LeBreton Library Parcel

Constructability Report

February 2023 | TYLin Ref. 10399

Dream Asset Management

SCALE:	1:750	PROJECT No.	10399
DATE:	APRIL 2022	FIGURE No.	1-1
DESIGNED BY:	n/a		
CHECKED BY:	C.B.

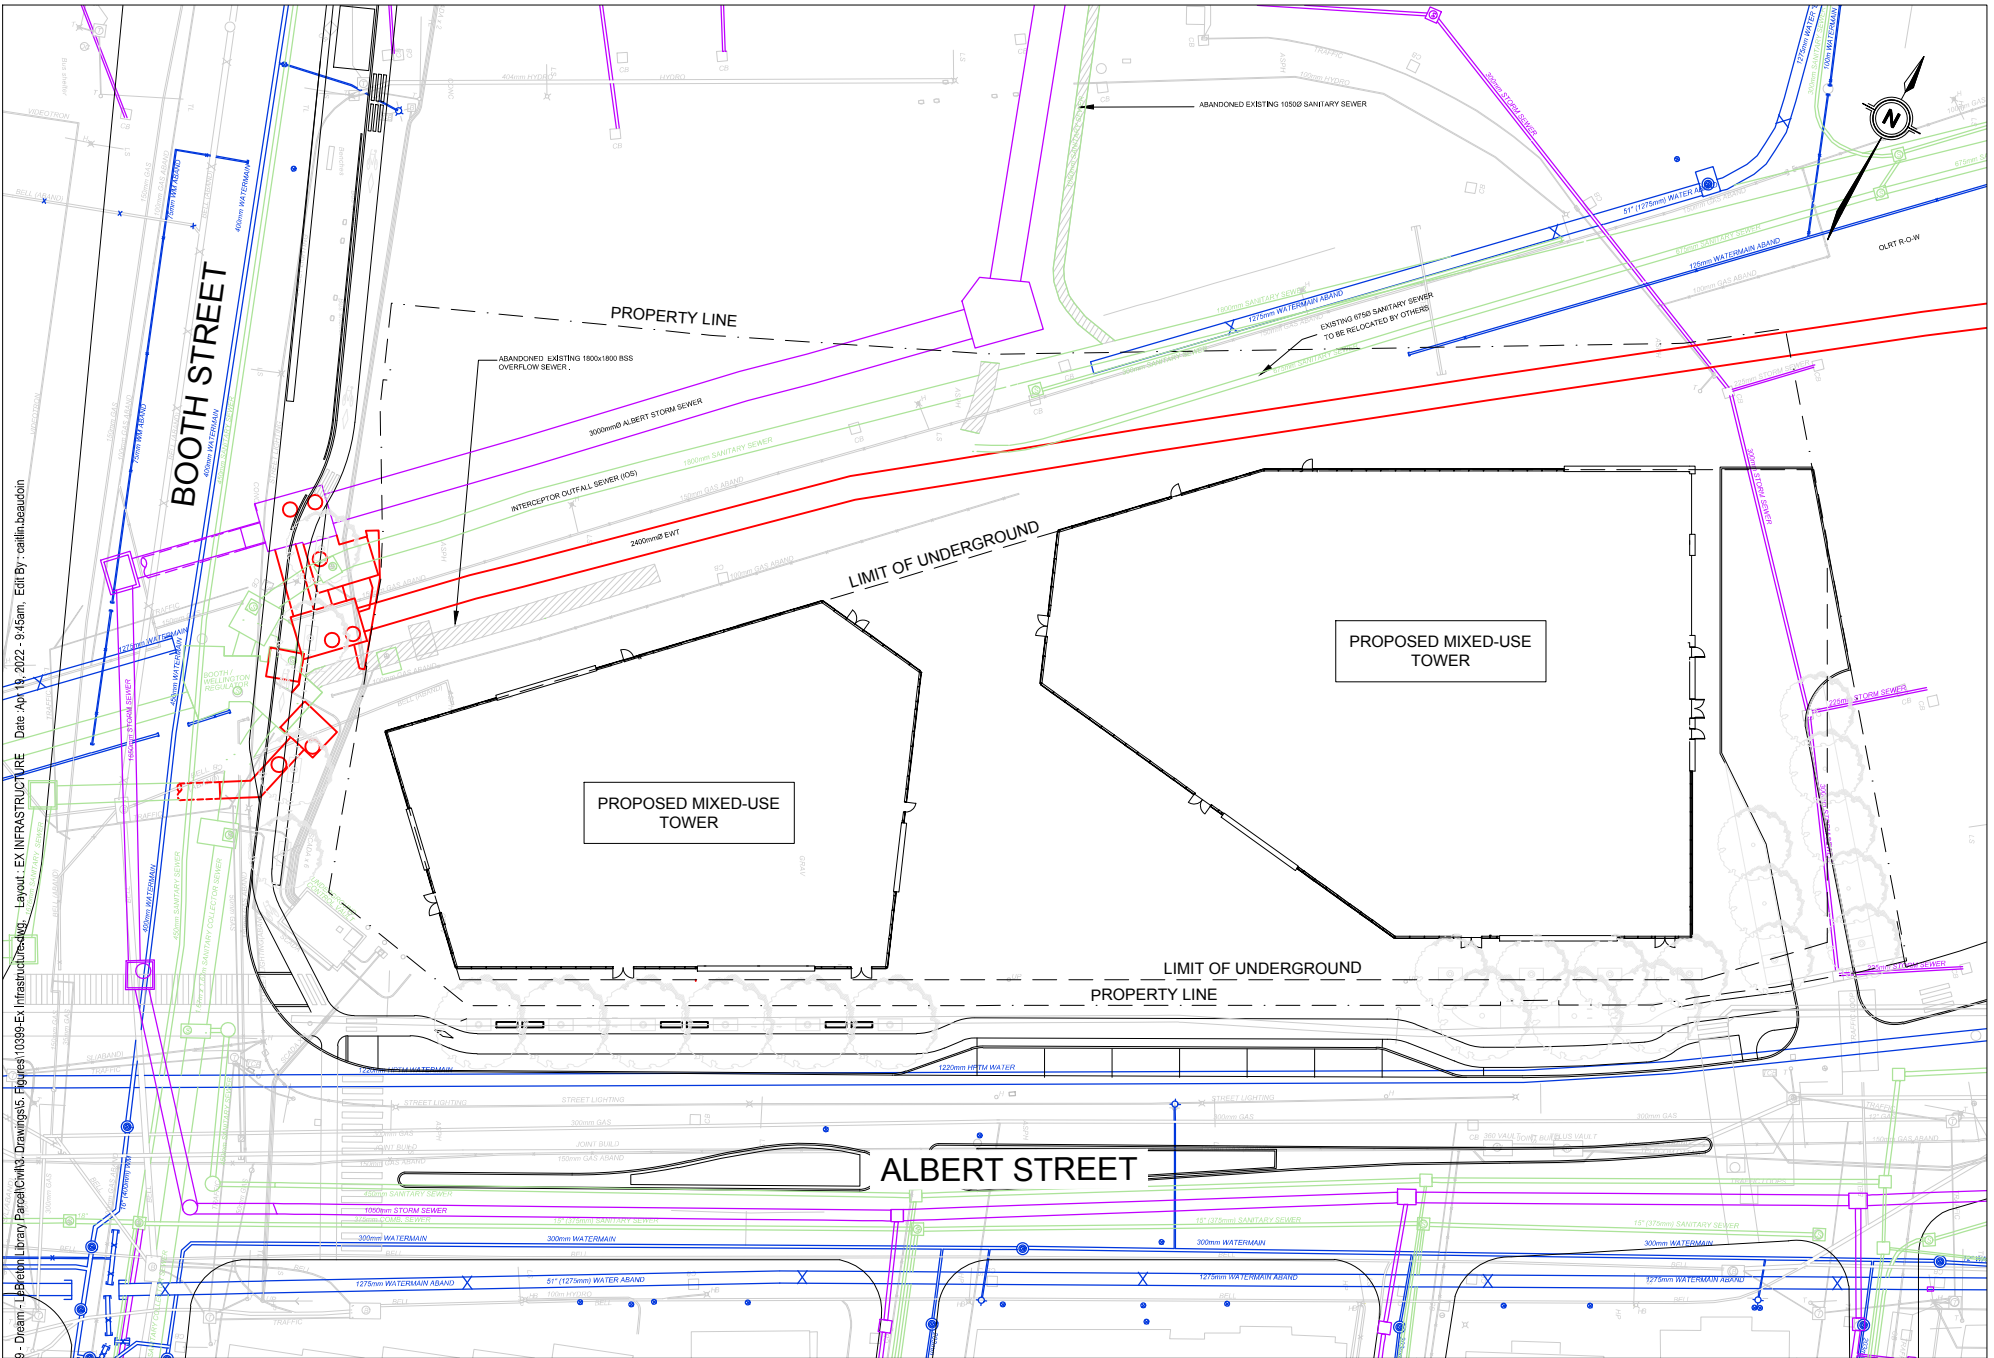
- a. The plans included within the constructability report (Figure 1-1) appears to show the existing Real Time Control (RTC) underground control vault at Booth/Albert and the associated underground ductbanks from this vault to the RTC facilities. It is unclear how/if the infrastructure is affected by the work, but this should be reviewed and addressed by the proponent. Excavations may extend into the footprint of the vault and the ductbanks, potentially requiring temporary support and protection.

- a. The plans included within the constructability report (Figure 1-1) appears to show the existing Real Time Control (RTC) underground control vault at Booth/Albert and the associated underground ductbanks from this vault to the RTC facilities. It is unclear how/if the

Figure 3-1 LLP-LOG-02 Extract

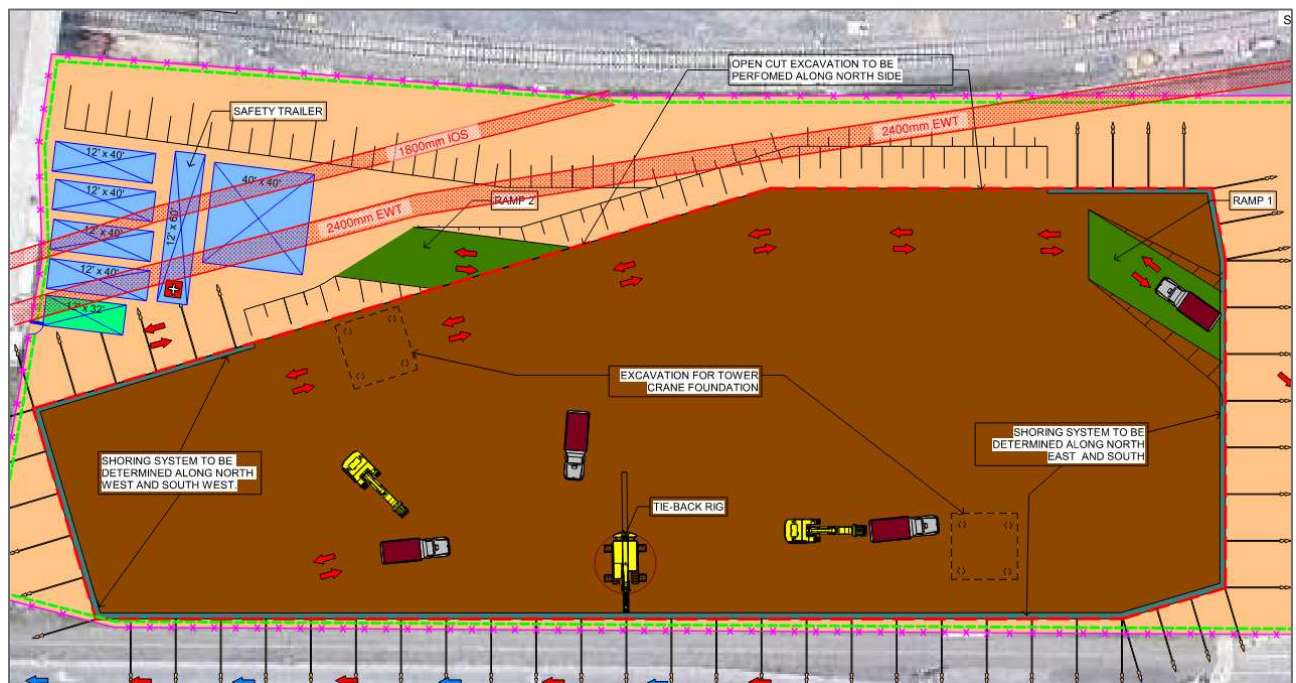
Revised report does not address comment fully. However, landscaping cross-sections illustrate that final grades for the MUP (lowest elevation area of site) will be at 56.0m at a minimum, consistent with the grades of the existing LRT tracks that are above-adjacent to the existing sewer infrastructure. It is assumed that the construction site overtop of the EWT and IOS will not be excavated lower than 56.0m outside of the shoring system (essentially existing grades). Provide confirmation whether any protective measures would be required to protect the sewers from construction activity/equipment.

In response to this comment, we note that no excavation lower than 56.0m is proposed over City infrastructure. As per the ED Logistics Plan Excavation Figure LLP-LOG-02 (**Appendix F**) and Marathon Shoring Plan (**Appendix E**), construction site grades in the northern portion of the site over existing City infrastructure will generally not vary significantly from the existing condition. As indicated in **Figure 3-1** (a marked-up extract of the Ellis Don Logistics Plan Grading Figure LLP-LOG-02 to show approximate alignment of EWT/IOS), City infrastructure lies outside of, or close to, the indicated top of slope linework. In localized areas some precut (to an elevation of 59.0m) will be necessary as part of excavation shoring (see Marathon Drg. MU4). On this basis, no additional protective measures are considered necessary.

Figure 1 - Example Cross Section Along North Foundation Wall

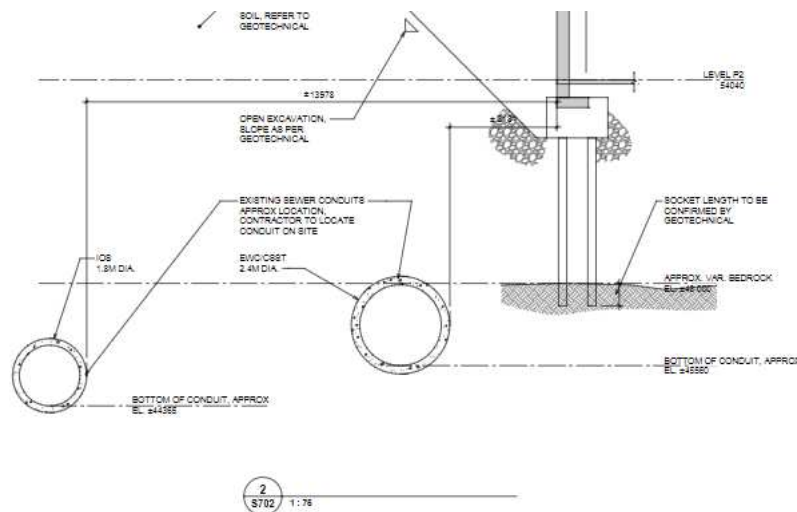
2. **Drawings and Construction Plans:** The developer should provide plans showing details of the proposed shoring system and permanent underground works, showing details on proximity to the EWT at several cross sections along the development. The cross section should also include any required temporary shoring and/tie backs that may be required to perform the work, including limits of excavation.

Based on information contained in the Stantec memo as well as the RJC drawings, there is an existing 2.4 m diameter precast concrete sewer which forms part of the CSST infrastructure. This sewer is referred to as the EWT tunnel. The EWT tunnel is located 3.2 m from the exterior wall at its closest point to the new building (see Section 2 on Sheet 702 of the RJC foundation drawings). At all other locations the distance is greater than 3.2 m.

- Comment 3a: Golder has reviewed the foundation drawings and confirms that there are no additional loads expected to be applied to the EWT by the proposed foundations.
- Comment 3b: The current RJC drawings indicate that the caisson foundations will have a diameter of 1.2 m and will have a rock socket depth of 3 to 4 m.
- Comment 3c: The statement is not included in the geotechnical report because the foundations were not designed at the time of preparing the report. We believe this statement in the constructability report refers to subsequent correspondence and discussion. Regardless, it is Golder's opinion that the currently proposed foundations should not impose any significant stress increase to the existing services in question and, notwithstanding the reference, the statement in the constructability report is generally valid.

- Comment 3d: The caissons are designed to have a rock socket depth of 3 to 4 m which is approximately 3 times the proposed diameter. This would typically be sufficient to be considered fixed (though the quality of the rock sockets does need to be confirmed during construction).

- Comment 3e: Given the discussion above, the increase in stress due to the permanent foundations is expected to be essentially zero.
- Comments 4a to 4e: These comments relate to shoring and temporary works which are designed by others. Golder would be pleased to provide additional review as required as these aspects of the project are designed in further detail.
